### **REMARKS**

This Amendment is responsive to the Office Action of November 25, 2002. Reconsideration of the rejections of Claims 1-10 and 12-17 is respectfully requested. By this Amendment Claims 1, 7, 8 and 13 have been amended. Claim 11 has been cancelled. New Claims 17-24 have been added and consideration of these new claims is requested.. The amendments and new claims do not add new matter. Allowance of the claims of this application is requested.

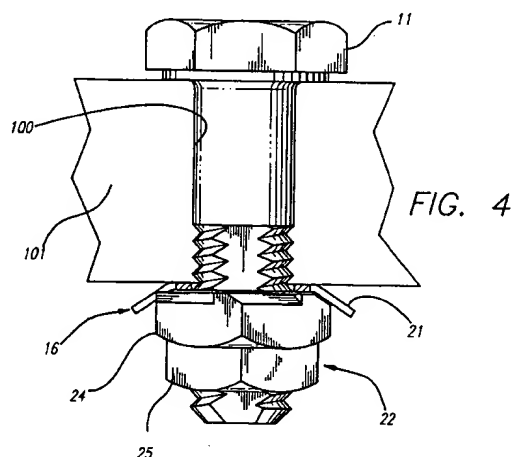
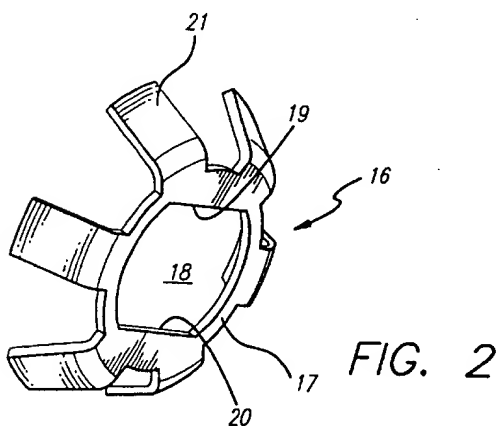
original specification, namely Figures 1, 3 and 4. Duran discloses a nut and bolt locking system with a washer 16 having a main body portion 17 and a number of spaced ears 21 (see Figures 2 and 4 from Duran reproduced below). The ears 21 are angled with respect to the main body portion 17, but are not generally perpendicular to the main body portion 17. In combination, the main body portion 17 and ears 21 do not have a cup shaped configuration, particularly when the washer is in place against the nut. Additionally, the washer of Duran would not function if having a cup shaped configuration. Ears 21 which would be generally perpendicular to the main body portion 17 would not properly engage with the angled flats on the face of the nut. Thus the disclosure of Duran does not anticipate Applicant's Claims 1 or 8 and reconsideration is required.
